PROJECT NAME: Esplanade at Starkey Ranch - MPUD Non-Substantial Modification

PROJECT NO. (FROM CURRENT PLANNING): PDD15-498 (RZ7078)

RE: Starkey Ranch MPUD Non-Substantial Modification (PDD15-498)

Please find the below information in response to Staff's review comments received via email on January 14, 2015 in regards to Starkey Ranch MPUD Non-Substantial Modification.

SWALE CAPACITY CALCULATIONS

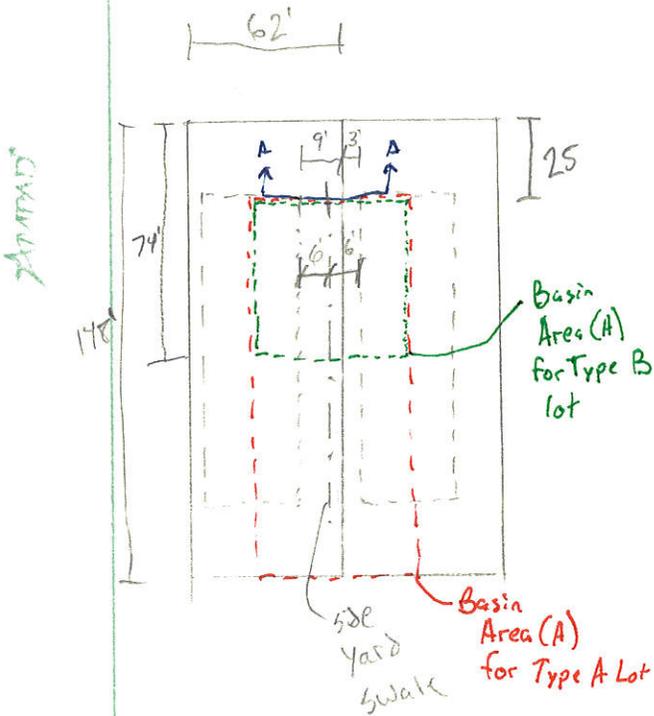
4. Must prove that storm water works in site design review process. Concern about 148' lots that cannot drain to the rear.

RESPONSE: The enclosed swale capacity analysis demonstrates the proposed design functions for the largest proposed lots (62' wide X 148' deep), for both "A" and "B" graded lots.

**** Based on Swale Demand of 0.02 cfs for a Type A lot and 0.01 cfs for a Type B lot, the proposed side yard swale has adequate capacity.**

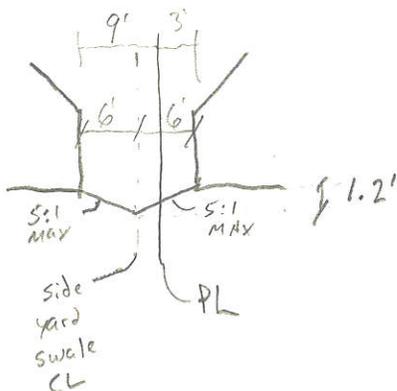
3. Drainage easements and fencing. Please refer to the revised narrative and swale capacity analysis.

RESPONSE: The Applicant is proposing a 1-foot encroachment of the a/c pad within the 5' drainage easements. The analysis demonstrates that this design proposal will not negatively impact stormwater management systems within the project. The construction plan submittal and SWFWMD permits will demonstrate that the proposed stormwater management system will not result in adverse off-site impacts.

Type B Lot

$$Q_{25} = 0.01 \text{ cfs for Type B lot}$$
